rainTree consulting

DA2020/0046
22 OCEAN ROAD – PALM BEACH, NSW
STORMWATER (SW) DISCHARGE PROPOSAL
GENERAL ARBORICULTURAL ADVICE
Ref No: RTC-8920

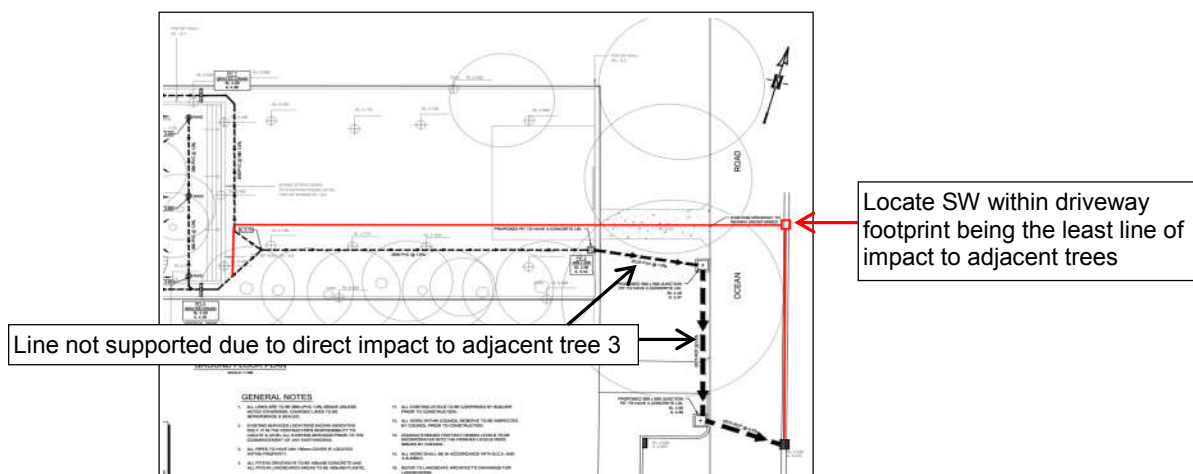
Summary of assessment: The proposed SW layout plan was determined as having a detrimental impact to adjacent tree 3.

The redirection of the SW proposal as shown below was determined as the most suitable location for drainage as having the least impact to discharge storm water to Ocean Road.

Prior to any excavation within specified tree protection zones further advice from an appointed project arborist is required. Where excavation within structural root zone setbacks occurs prior non-destructive tree root investigations are required to provide more advice on the location, distribution and impact on critical underlying tree roots. All works within tree protection zones are to comply with tree protection measures as specified within the development conditions of consent under DA2020/0046.
